Change Request form

General Information (Origin of Request)			
<input checked="" type="checkbox"/> User Requirements Document (URD)			
<input checked="" type="checkbox"/> Other User Functional or Technical Documentation (SYS)			
<input type="checkbox"/> Other TIPS Documentation (OTD)			
<i>(to be filled in by CoG)</i>			
Request raised by: Market Infrastructure Board (MIB)		Date raised: 29/06/2018	
Request title: CMB limit utilisation reset		Name of Central Bank: European Central Bank	Request ref. no.: TIPS 0008 URD
Categorisation of changes			
1. Functional/technical importance parameter: Medium		4. Legal importance parameter: Low	
2. Operational importance parameter: High		5. Financial importance parameter: Low	
3. Stakeholder importance parameter: High			
Status: Draft

Scenario 1 - Example

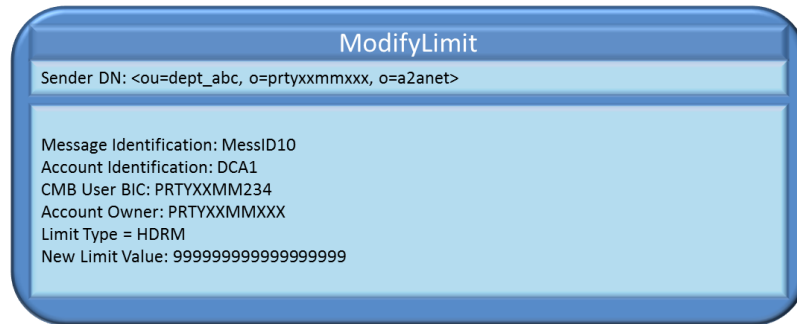
In this scenario a TIPS Participant (with BIC 'PRTYXXMMXXX') resets the CMB limit headroom of a CMB (of a Reachable Party identified by the BIC 'PRTYXXMM234') under its data scope. TIPS Account with identifier equal to 'DCA1' is linked to a CMB whose limit value is equal to 1000.00 EUR and CMB limit headroom equal to 600.00 EUR.

The system, after performing the expected checks successfully, completes the requested amendment: it resets the CMB limit headroom to the current limit value for the CMB (1000.00 EUR) and sets the CMB limit utilisation to 0.00 EUR.

Scenario 2 - Example

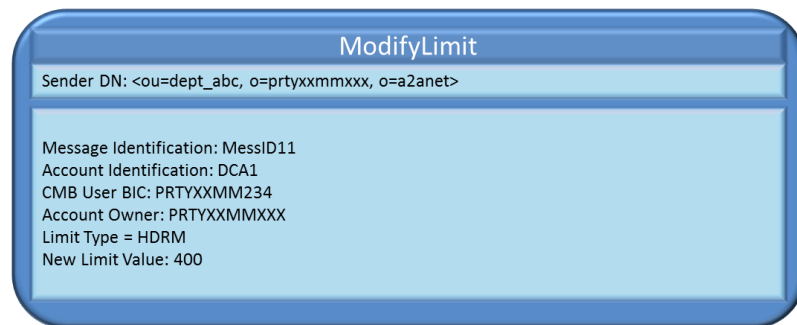
In this scenario a TIPS Participant (with BIC 'PRTYXXMMXXX') sets the CMB limit headroom of a CMB (of a Reachable Party identified by the BIC 'PRTYXXMM234') under its data scope to a specific value (400.00 EUR) lower than the value of the CMB limit. TIPS Account with identifier equal to 'DCA1' is linked to the CMB whose limit value is equal to 1000.00 EUR and the CMB limit headroom is equal to 700.00 EUR.

The system, after performing the expected checks successfully, completes the requested amendment: it sets the CMB limit headroom for the CMB to 400.00 EUR and CMB limit utilisation to 600.00 EUR.

Scenario 3 - Example

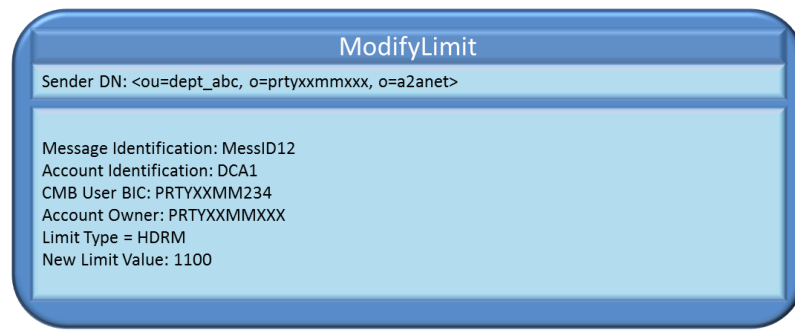
In this scenario a TIPS Participant (with BIC 'PRTYXXMMXXX') sets the CMB limit headroom of a CMB (of a Reachable Party identified by the BIC 'PRTYXXMM234') under its data scope to a specific value (1100.00 EUR) greater than the value of the CMB limit. TIPS Account with identifier equal to 'DCA1' is linked to the CMB whose limit value is equal to 1000.00 EUR and the CMB limit headroom is equal to 700.00 EUR.

The system, after performing the expected checks successfully, completes the requested amendment: it sets the CMB limit headroom for the CMB to 1100.00 EUR and CMB limit utilisation to -100.00 EUR.
